- 9. Cottonwood Acres Subdivision 2024 Addition
KPB File 2024-024
McLane Consulting Group / LCF Holding, LLC
Miracle Avenue & Dana Bayes Street North
Kalifornsky Area**

COTTONWOOD ACRES SUBDIVISION 2024 ADDITION

ITEM #9 - PRELIMINARY PLAT
COTTONWOOD ACRESSUBDIVISION 2024 ADDITION

STAFF REPORT

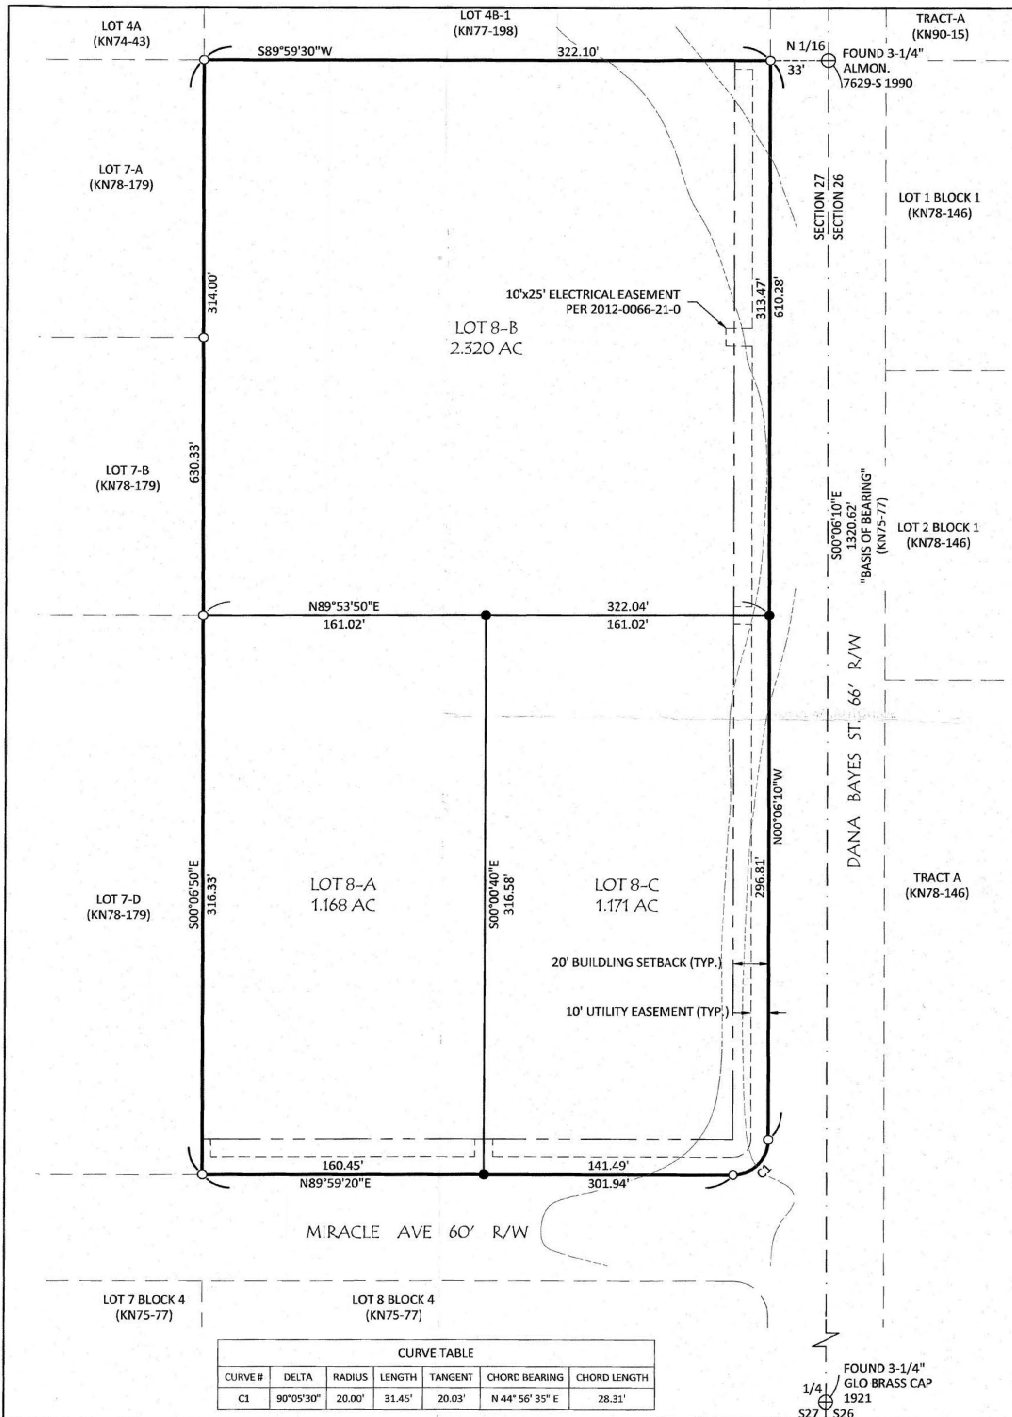
Legal access to the plat is on Dana Bayes St and Miracle Ave, which are both 60' borough maintained dedications. Lot 8-B will continue to have access from Dana Bayes St. Lot 8-A will have access from Miracle Ave. Lot 8-c will have access from both Dana Bayes St and Miracle Ave. RSA review has concerns about driveway placement for Lot 8-C off of Miracle Ave due to the closeness to the corner. **Staff recommends:** a note be added of this concern and a recommendation to consult with RSA on driveway placement.

In the southeast corner of the plat, the road appears to possibly be crossing the corner of the property. Surveyor should locate the edge of road to property line and if inside the property, show on plat and consult with RSA about issue. **Staff recommends:** if the road is an issue to be resolved by dedication, the Committee concur the dedication be added to the final to fix the encroachment issue.

There is a utility easement listed in the Certificate to Plat. HEA has requested that the drawing listing of the filing, match the CTP and the plat note. HEA has also stated that plat note 5.1 can be removed as the document noted does not affect this plat.

The easement listed in document 2012-006621-0 is a separate easement from the 10' utility easement along the right-of-way and should be shown that way. **Staff recommends:** that the 10' by 25' easement lines be extended to the east line of the plat.

HEA	Plat note 5.1 does not affect this plat and can be removed. Make the filing information on the note on the drawing portion match the plat note at 5.2.
ENSTAR	No Comment
ACS	No objections
GCI	No Comment

Addressing	<p>Reviewer: Leavitt, Rhealyn</p> <p>Affected Addresses: 35735 DANA BAYES ST N</p> <p>Existing Street Names are Correct: No</p> <p>List of Correct Street Names: DANA BAYES ST N, MIRACLE AVE</p> <p>Existing Street Name Corrections Needed: PLAT NEEDS TO CORRECT TO DANA BAYES ST N</p> <p>All New Street Names are Approved: No</p> <p>List of Approved Street Names:</p> <p>List of Street Names Denied:</p> <p>Comments: 35735 DANA BAYES ST N WILL REMAIN WITH LOT 8-B.</p>
Code Compliance	<p>Reviewer: Ogren, Eric</p> <p>Comments: No comments</p>
Planner	<p>Reviewer: Raidmae, Ryan</p> <p>There are not any Local Option Zoning District issues with this proposed plat.</p> <p>Material Site Comments: There are not any material site issues with this proposed plat.</p>
Assessing	<p>Reviewer: Windsor, Heather</p> <p>Comments: No comment</p>
Advisory Planning Commission	Kalifornsky APC not active

- D. A vicinity map, drawn to scale showing location of proposed subdivision, north arrow if different from plat orientation, township and range, section lines, roads, political boundaries, and prominent natural and manmade features, such as shorelines or streams;
Staff recommendation:
Add road lines and name labels to road to get to site and around It from Kalifornsky Beach Rd
- G. The status of adjacent lands within 100 feet of the proposed subdivision boundary or the land status across from any dedicated rights-of-way that adjoin the propose subdivision boundary, including names of subdivisions, lot lines, block numbers, lot numbers, rights-of-way; or an indication that the adjacent land is not subdivided;

Lots to the west need Block 3 added to the lot label
Lot to the north needs Block 2 added to the lot label
Tract to the east need Block 1 added to the lot label

- J. Block and lot numbering per KPB 20.60.140, approximate dimensions and total numbers of proposed lots;
Staff recommendation:
Add Block 3 to lot labels
- N. Apparent encroachments, with a statement indicating how the encroachments will be resolved prior to final plat approval;
Staff recommendation:
Road appears to cross southeast corner of lot. Check with roads department to see if need to address issue and if so, do dedication to take road out of property.

Measured and recorded data needs shown on the plat where appropriate.

Label block 3 on each lot.

Easement listed in 2012-006621-0 is a 10'x25' easement and is separate from the 10' utility easement on the front of the lot, therefore should be shown as such. Extend east/west lines to the east line of the plat as described.

Add the date of March 25, 2024 to the Plat Approval
